**Federal Highway  
Administration**

April 27, 2005

Thank you for writing on this subject. If you have any questions, please call Mr. Scott W. Wainwright of our staff at 202-366-0857. Please note that we have assigned your request the following official interpretation number and title: "3-178(I)—Retroreflective Colored Pavement – Additional Clarification." Please refer to this number in any future correspondence.

**SUBJECT: Request for Interpretation – MUTCD Section 3B.17 Crosswalk Markings**

**Picture ID:** 613

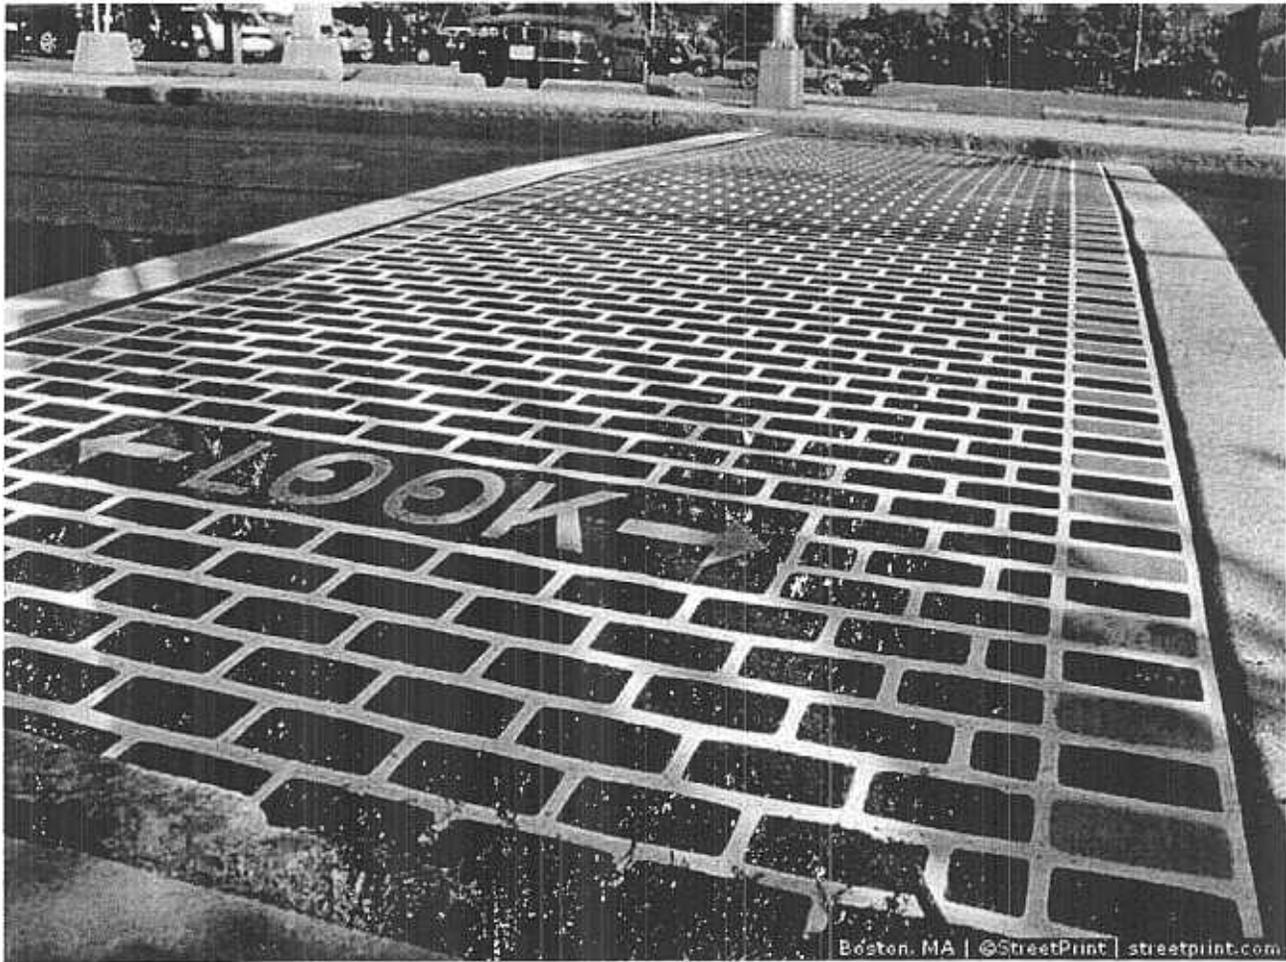
In summary, it is our interpretation that all of the examples of "StreetPrint DuraTherm" crosswalk pavement treatments shown in the photographs included with your letter are not in compliance with the MUTCD. If the City of Bellevue wishes to use these or similar types of markings, it is necessary to request experimentation approval from FHWA as per Section 1A.10 of the MUTCD.
